Verdant Minerals Pty Ltd Ammaroo Phosphate Project - EIS Supplementary Report

August 2018

The EIS was circulated to agencies and available for public comment. A total of 150 written submissions (e.g. comments) on the EIS were received from NT Government advisory bodies and agencies, and two non-government organisations.

Figure 3-1 Down-gradient concentration of a plume

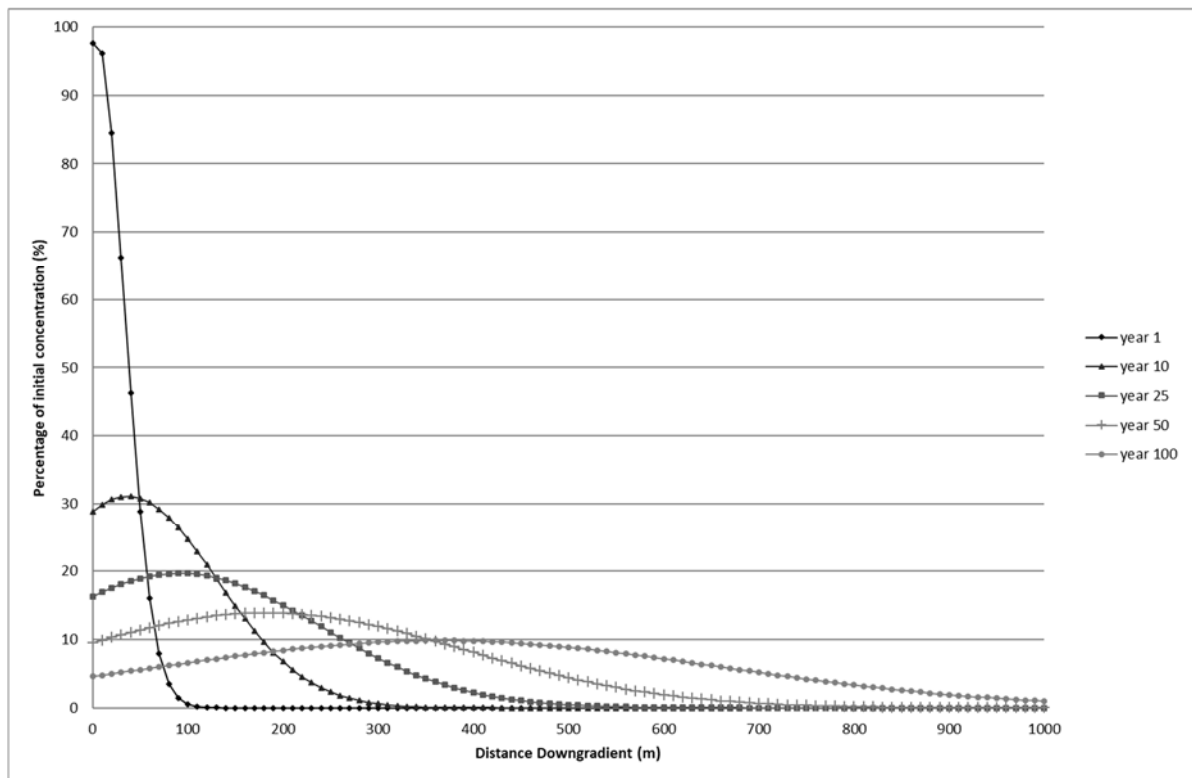
30	NT EPA	Tailings Seepage – Chemical impacts of tailings	Appendix H – Ammaroo Phosphate	<p><i>Saline tailing seepage will not be generated due to the low salinity of process water.</i> (p.38).</p> <p>Provide details of future tailings leachate test work to confirm seepage from tailings would not be saline.</p>	<p>Further test work of synthetic tailings was undertaken in December 2017 and confirms the low contaminant concentrations for a range of leaching solutions. Further information is available in Section 3.1.1. A copy of the SGS Report is provided in Appendix 8.</p>

The calculated down-gradient concentration of tailings leachate is presented as Figure 3-1. The plume moves very slowly due to the low hydraulic conductivity of the basement rock and the

The calculation is conservative in that it considers a starting concentration of 100% leachate. In reality leachate will seep vertically to initially mix with the water table beneath the tailing facilities and result in a starting concentration much less than 100% leachate.

Given that the starting water quality of each fluid is comparable (both suitable for stock use, but not potable use) the impact is negligible regardless of dilution.

Figure 3-2 Tailings dry density – moisture content relationship

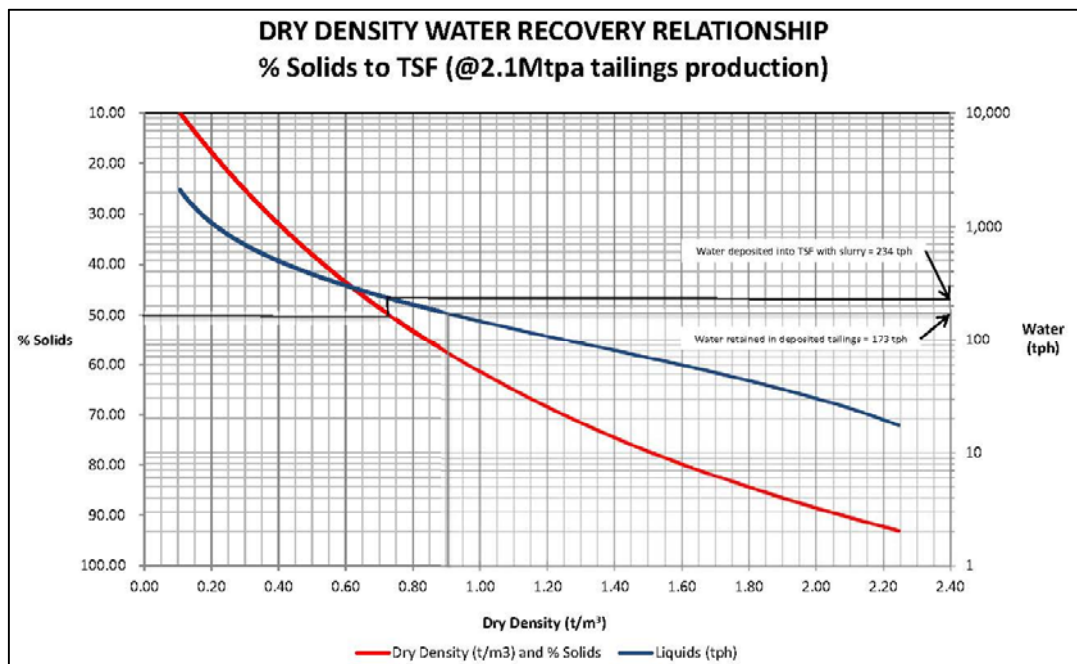
23	NT EPA	Tailings management	Appendix G – Surface water impact assessment 2.2.4	<p>Dry tailings capped 1 – 2 m higher than surrounding land.</p> <p>Provide details on:</p> <ul style="list-style-type: none"> • Consolidation rate and behaviour of tailings • Monitoring details on tailings settlement rates to inform when capping of in-pit tailings can commence • Source and volumes required of capping materials for in-it and surface tailings storage facilities • Permeability of capping materials used to prevent infiltration • Progressive rehabilitation schedule for in-pit and surface tailings based on the above information. 	<p><u>TSF closure</u> Refer to comment 6 for information on surface and in-pit TSF closure.</p> <p>The first in-pit TSF (i.e. first mined pit) rehabilitated will include some level of experimentation to understand the exact nature of the final landform that can then be replicated across the site.</p> <p>Once the first 5 year pit has been mined, a series of rehabilitation trials will be undertaken which will provide a better understanding of:</p> <ul style="list-style-type: none"> • Tailings, waste rock and overall material consolidation • Level of consolidation required to cover • Landform stabilisation • Land form heights • Effectiveness of cover material • Effectiveness of revegetation options. <p>These tests will occur in the first mining area between years 5-10.</p> <p>In practical terms, the initial rehabilitation of the first 5 year mining area will determine the best approach to rehabilitation and closure of all future mine pit areas. The design of these rehabilitation trials will occur during the first 5 years of mining with due regard to the actual conditions experienced at the site once mining and in pit tailings deposition commences.</p> <p>Further consultations with the pastoralist and traditional owners will occur about the potential for alternate revegetation strategies that may result in some of the</p>

The relationship between the dry density of the tailings and the moisture content, for a tailings production rate of 2.1 Mtpa, is presented in Figure 3-2.

Sensitive community receptors Figure 3-3

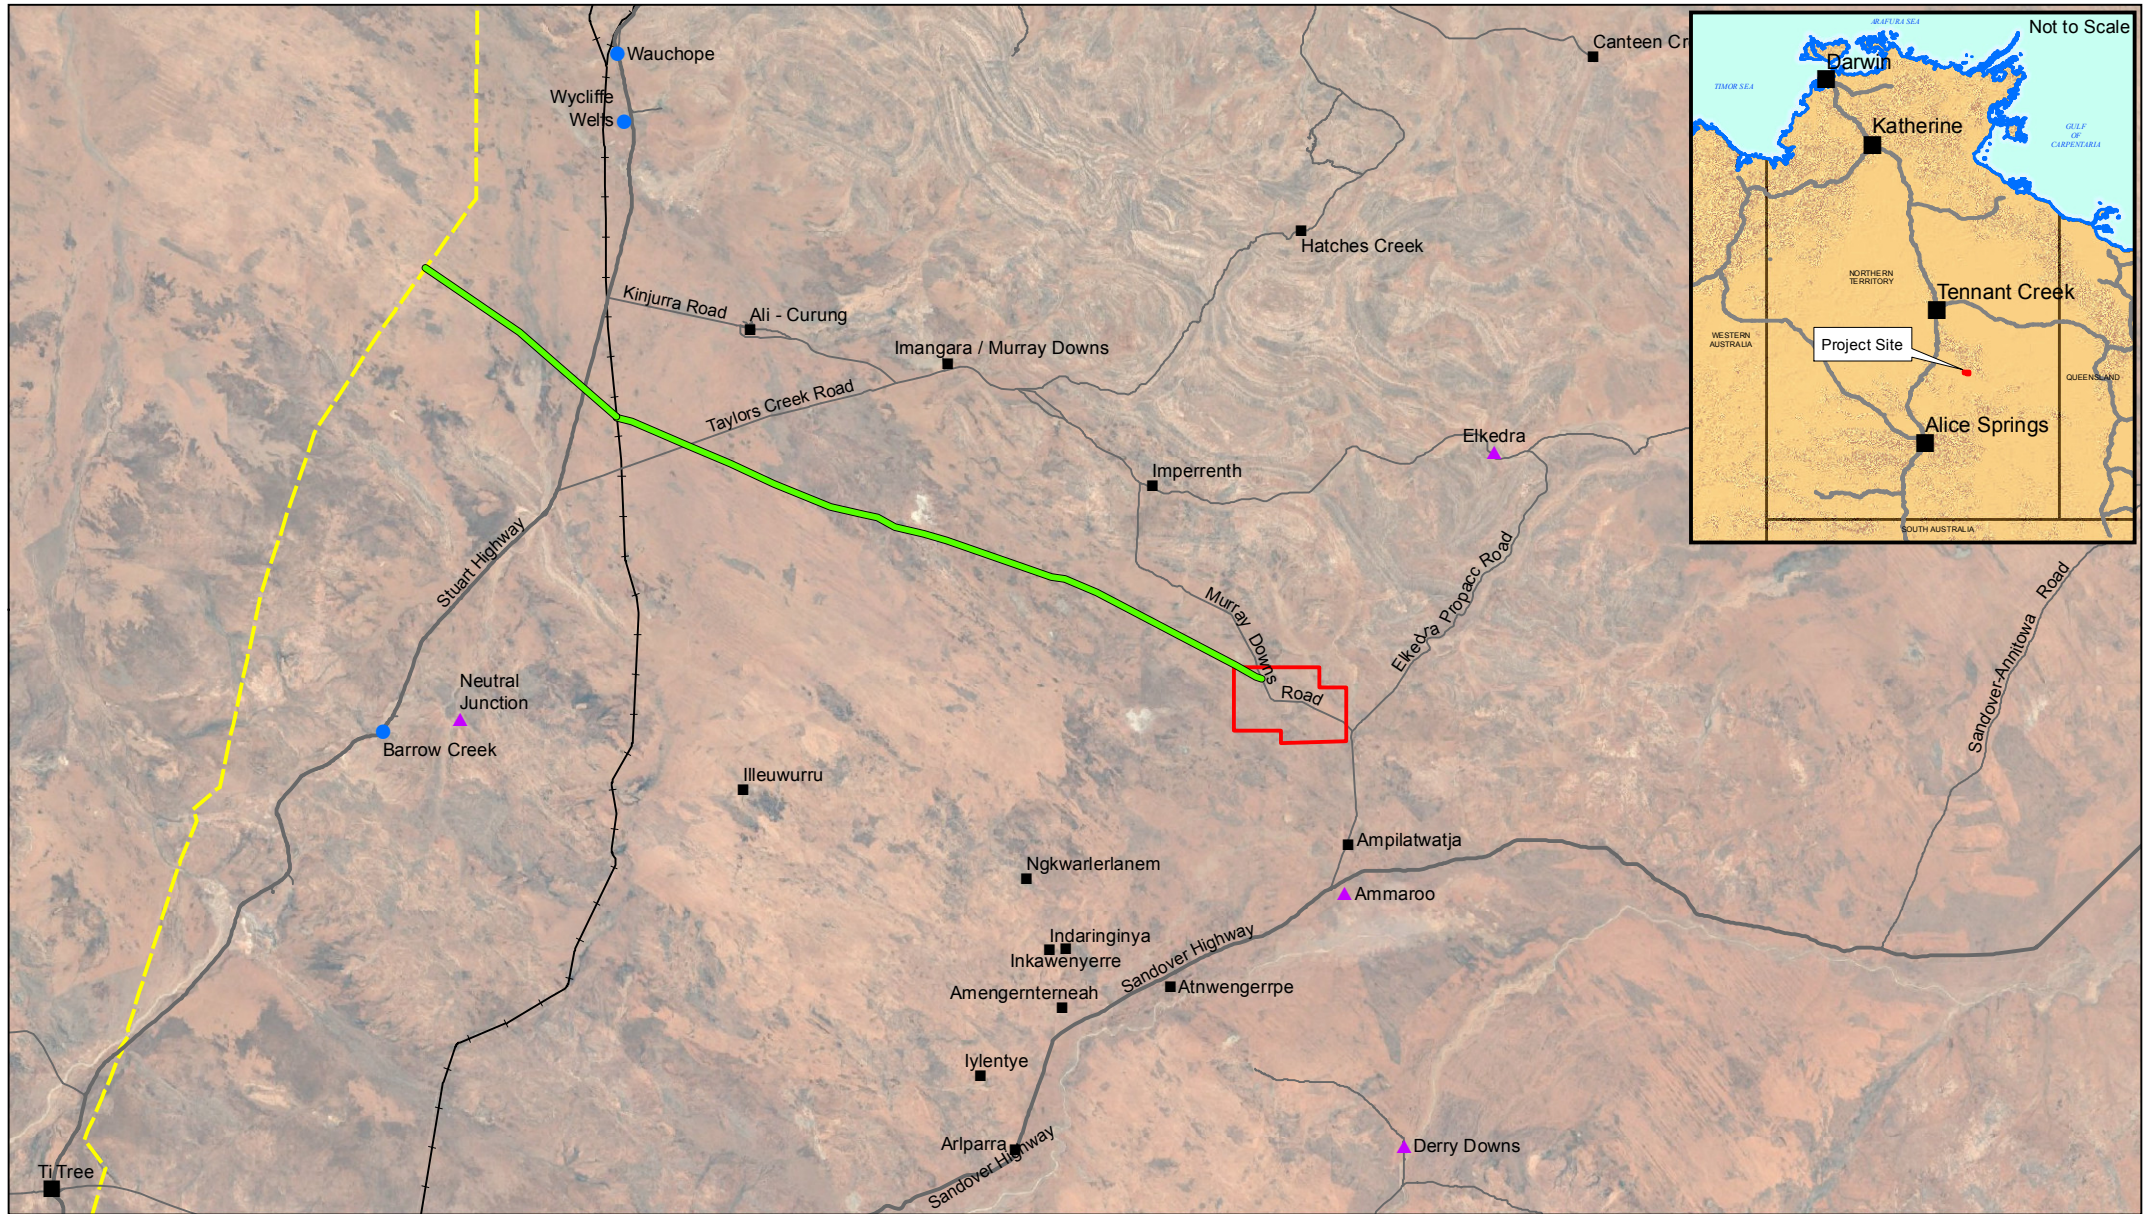
20	NT EPA	People and communities	Chapter 12 Socio-economic	Provide distances from the Project to the key communities to provide context of proximity of local stakeholders and sensitive receptors.	<u>Distances</u>

Sensitive community receptors for potential impacts from mining and/or transport infrastructure have been identified in Figure 3-3 and Table 3-15.

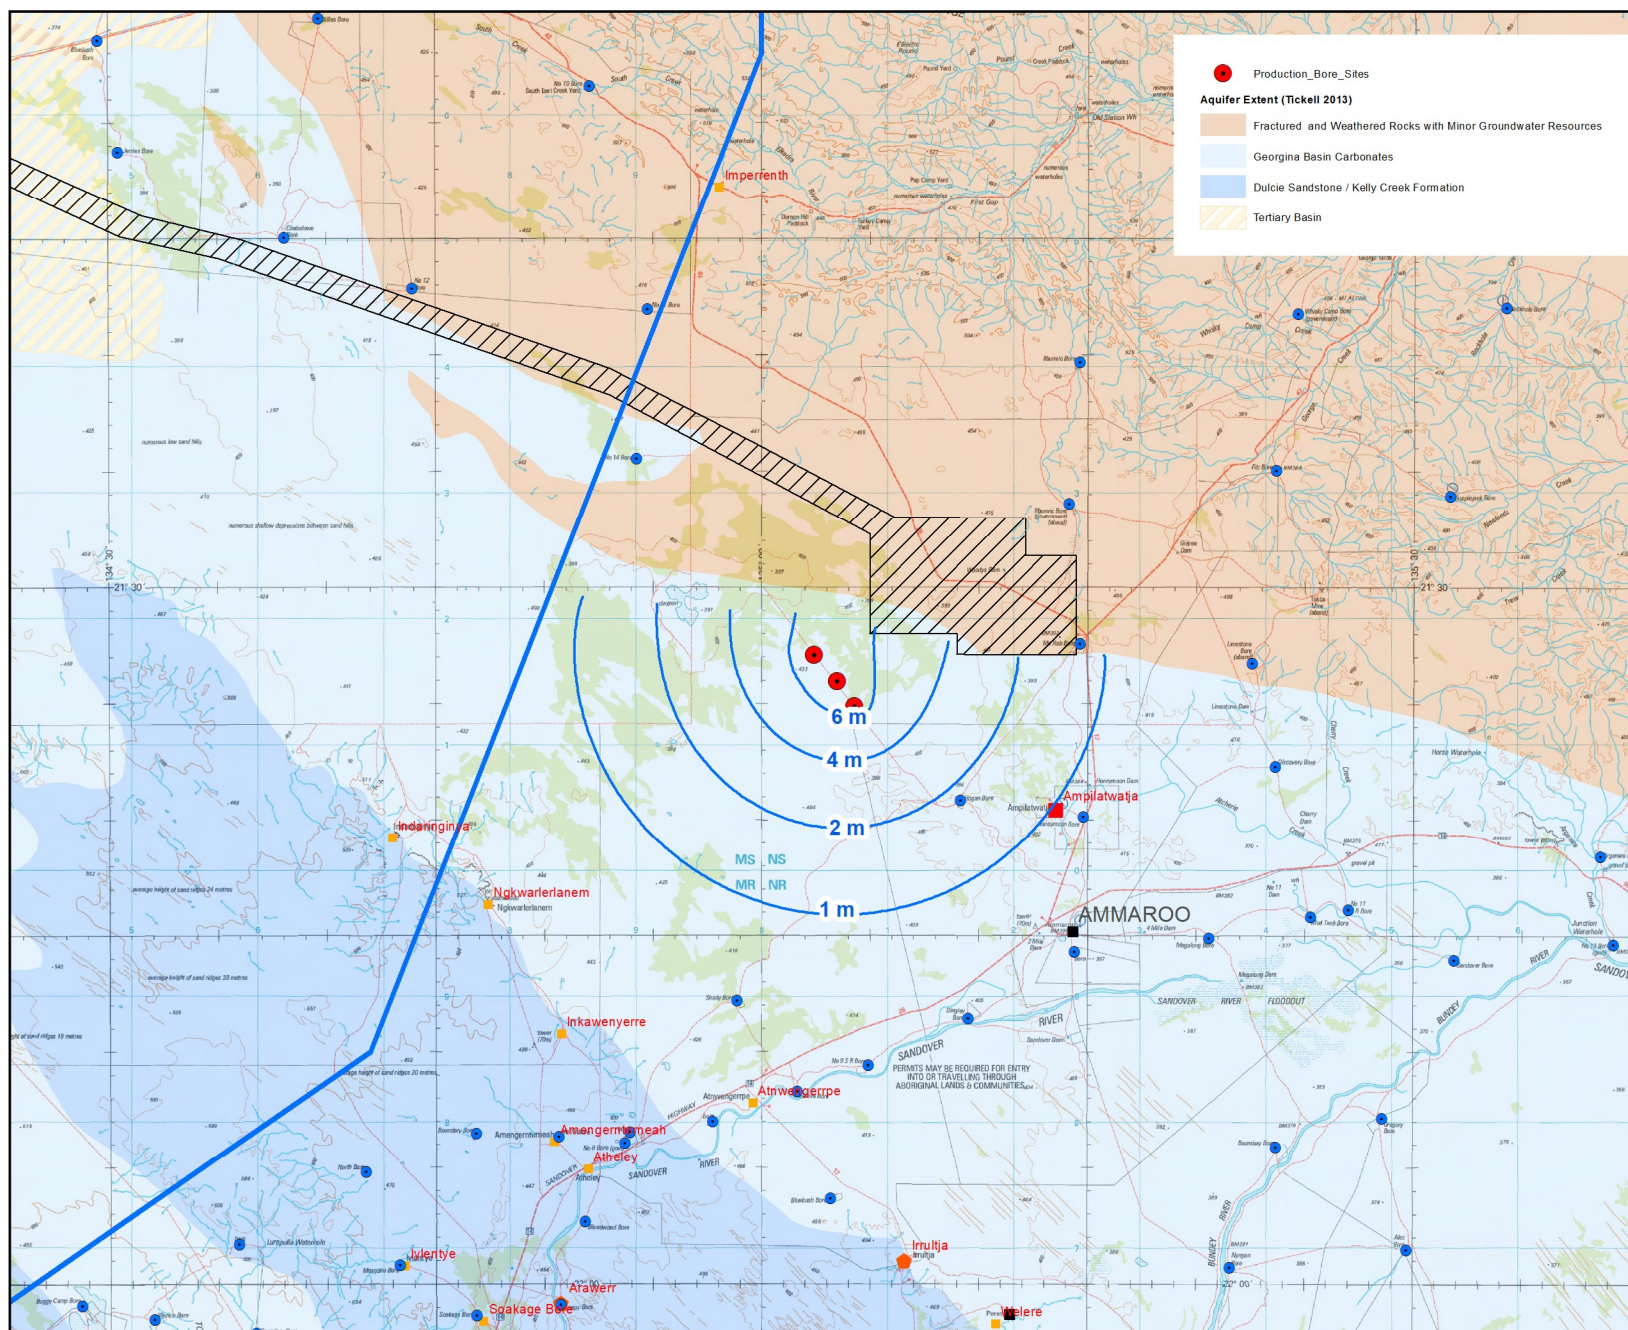
53	Department of Primary Industry and Resources	Impacts to Water	Water balance	The water balance provided in the draft EIS only considers inputs/outputs associated with processing (i.e. does not include rainfall or captured runoff) and does not take into account overall site water flows, including to storage facilities etc. Should the project proceed to assessment under the Mining Management Act, the operator will be required to provide a comprehensive water balance for whole of site and more details on water management, including a preliminary Water Account based on the MCA framework.	Noted.
54	Department of Primary Industry and Resources	Impacts to Water groundwater	Aquifer impacts	The potential for the project to impact on the overlying aquifers has not been described. Any connection to upper aquifers (Dulcie Sandstone and Tertiary) would mean risks exist. Impacts to the larger Georgina Basin Carbonate Aquifer may be trivial given its large size, but within smaller aquifers, the impacts potentially caused by the proposal may be significant. If the Georgina Basin Carbonate Aquifer is connected to the overlying aquifers please describe the potential impacts of the project on the any of the overlying aquifers. It is recommended that water resources section of DENR be consulted on the possible impacts to the aquifers.	The Georgina Basin Carbonate Aquifer is connected to the Dulcie Sandstone and Tertiary Aquifers. They are distinct geological units, however they are part of the same regionally extensive groundwater system. Drawdown in the Georgina Basin can impact on these aquifers. The extent of the Dulcie Sandstone and Tertiary Aquifers is shown in Figure 4 of the Ammaroo Groundwater Impact Study (Appendix H of the EIS). In the Ammaroo Groundwater Impact Study (Appendix H of the EIS), the Georgina Basin has been modelled as one continuous aquifer system, hence the model currently does simulate impacts on the Dulcie Sandstone and Tertiary Aquifers. The Tertiary Basins and Dulcie Sandstone are both outside the predicted radius of drawdown resulting from borefield pumping. The Tertiary basin extent is some 60 km to the northwest, while the Dulcie Sandstone extent is located some 35 km to the south west. Therefore, no impact on these aquifers is predicted. Additional detail is provided in 3.18 of the Supplementary.

The extent of overlying aquifers is presented on Figure 3-15.

The closest margin of the Tertiary aquifers are located approximately 65 km to the northwest of the borefield.

The closest margin of the Dulcie Sandstone aquifer is located 25km to the southwest of the borefield.

Drawdown from borefield pumping at the end of mining is also presented on Figure 3-15.

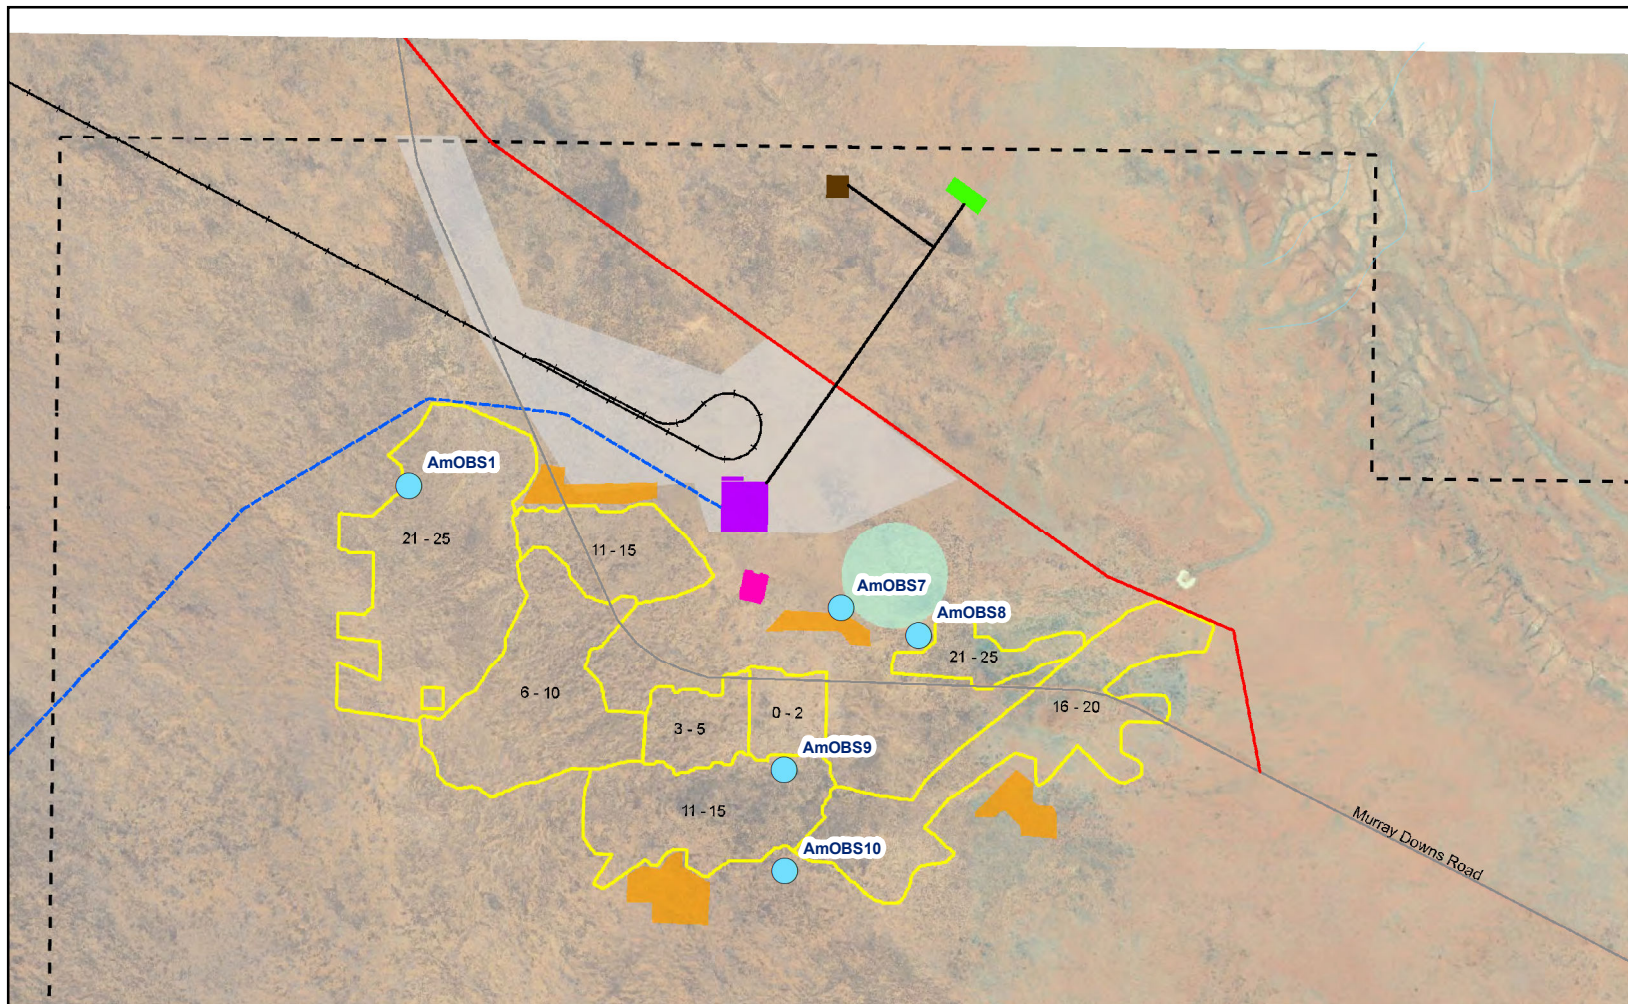
69	Department of Environment and Natural Resources, Rangelands, Water Resources and Flora and Fauna Divisions	Water resources Groundwater Monitoring	Section 6.2 Appendix H	<p>Monitoring is proposed by Verdant; however, it appears that this is yet to start. Although specialist monitoring bores are proposed (Section 6.2, Table 7, Figure 22), no mention of when these bores will be drilled, how they will be constructed etc. is presented. This is less than desirable as monitoring should begin before a mine starts not after; this way any changes from the pre-mining situation can be assessed.</p> <p>The monitoring program proposed by Verdant (Section 6.2) is considered inadequate. The monitoring bores are only proposed within the predicted area of drawdown from the borefield, no Verdant monitoring bores are proposed to be drilled beyond the predicted impact area (Figure 22). Furthermore, the reliance on existing stock or station bores as observation bores both beyond and within the predicted impact area is not adequate as access and suitability of bore conditions cannot be guaranteed in such bores. Purpose built dedicated monitoring bores is the usual expectation for monitoring points for groundwater appraisals.</p>	<p>The monitoring implementation schedule is detailed in Section 4.5.2 of the Water Management Plan (refer Appendix 6) and described in Section 3.19.2 of this supplementary report.</p> <p>Purpose built monitoring bores adjacent other users (e.g. Stock, Station and Community bores) will be located 200 m from the third-party users bore. Details are provided in the Water Management Plan. Section 4.5.1 and Section 3.19 of this Supplementary Report. Maps are shown as Figure 3-16 and Figure 3-17.</p>

Groundwater Monitoring to measure the impact of tailings seepage is detailed in Table 3-35 and Figure 3-17. Two bores will be located down-gradient of the Ex-pit TSF, and two bores will be located down-gradient of the in-pit tailing storage. The existing bore AMObs1 is located upgradient of the pits and provides baseline data.
